Project	NATIONAL MODELLING AND FORECASTING TECHNICAL SUPPORT CONTRACT 2018-19: Hydrodynamic model of Ickenham Stream and River Pinn at Ruislip Golf Course, Ickenham to understand the impact on the baseline flood risk at River Pinn resulting from the Ickenham Stream diversion in London				
Client	Environment Agency	Date	19/07/2019	Version	1.0
Reviewer	Rita Farkas	Checker	Siliva Garratini	Approver	Laura Baird

Model Originator	Ramboll, Skanska	Date	May 2019
Software	ESTRY-TUFLOW		
Available models	Baseline, Concept Design and a Temporary scheme and sensitivity runs		
Model Reviewed	Baseline, Concept Design and Temporary scheme		
Model Reports	Flood Levels Analysis Report - River Pinn and Ickenham Stream_FinalV3-signed.pdf		
Guidance	Environment Agency Management System – Operational Instruction (379_05) Computational Modelling to assess flood and coastal risk.

Figure 4: Mass balance plots for the 1% AEP event from Ramboll Modelling report, 2019

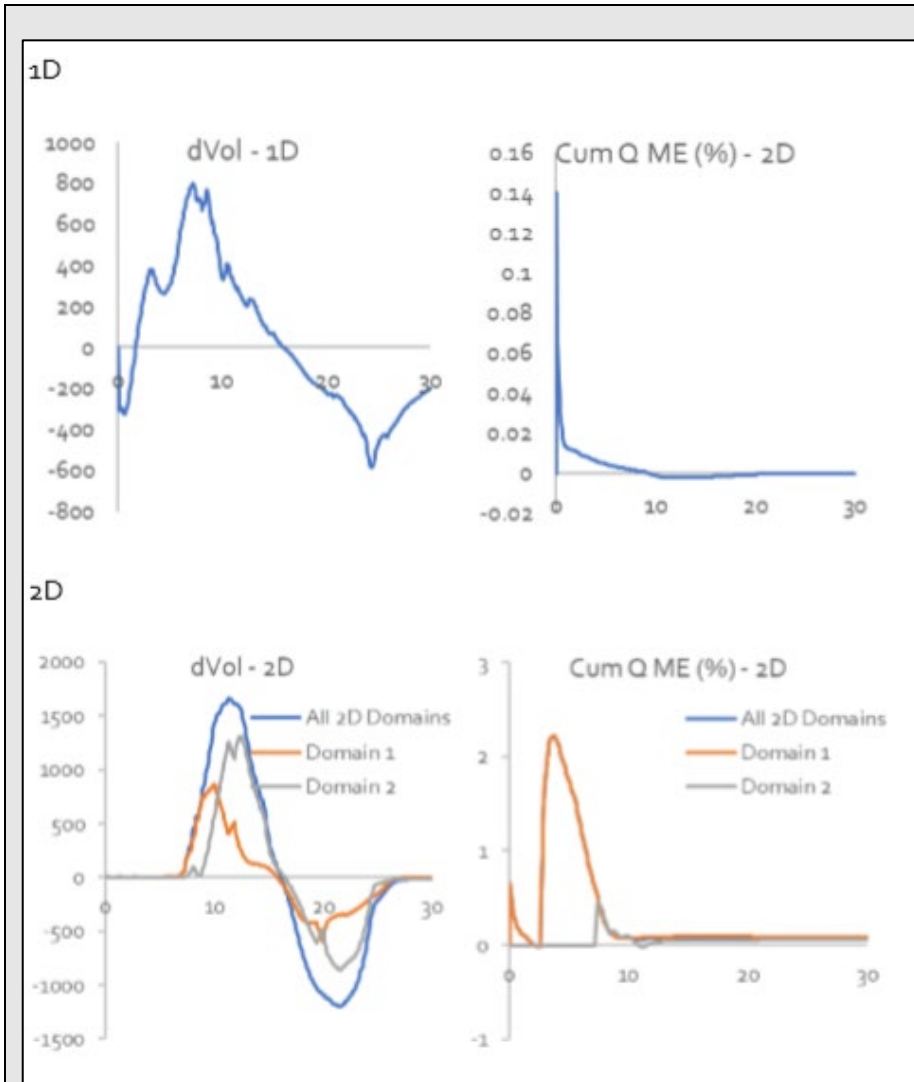
7. MODEL STABILITY & RUN PARAMETERS			Action RED: Action required AMBER: Action recommended GREEN: satisfactory GOLD: Exemplary practice
	Pass	Fail	NO ACTION REQUIRED
Has the model been run for long enough?	Pass, 30 hours.		
Is time step appropriate?	Pass, 0.5 s for the 1D and 1 s for the 2D.		
Are the simulation parameters within acceptable limits?	Pass.		
Are run-times acceptable?	Pass. 30 model hours took approximately 3 hours to run for the baseline 1% AEP scenario.		
Are changes in run parameters for different AEP's justified?	Pass. The depth limit factor has been raised from 10 to 50 from the 0.5% AEP event for stability purposes.		
Does model show acceptable numerical stability /mass balance?	Pass. A spike is observed in the 1D ESTRY domain at the start of the simulation, peaking at 0.14%, but this quickly returns to oscillate around 0%. A spike is observed in the 2D TUFLOW domain in domain1. This peaks at approximately 2.2%, but returns to zero before the flood peak.

Figure 5 Temporary design model schematisation

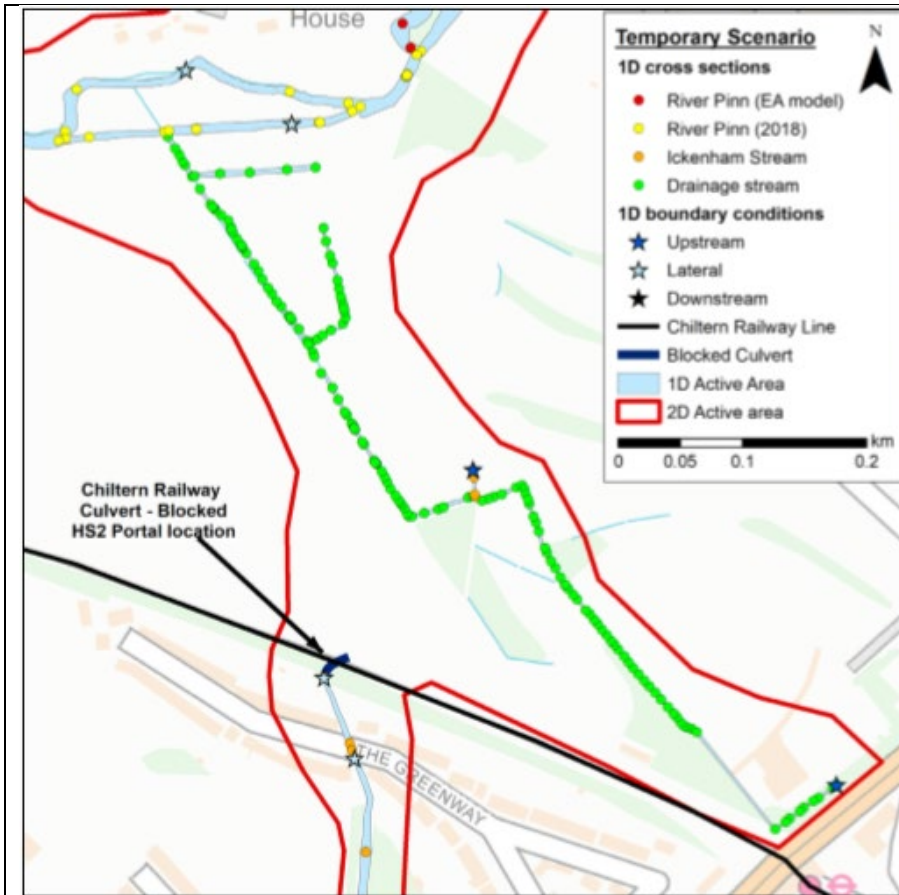
<p>The temporary diversion scenario blocks specific channels of the Ickenham Stream that allow flows to pass under the Chiltern Railway Culvert and diverting flows upstream of the Chiltern Railway Line along the existing drainage channels connecting the Ickenham Stream to the River Pinn. The difference between the baseline and temporary scenario setup are limited to the Ruislip Golf Course area.</p>
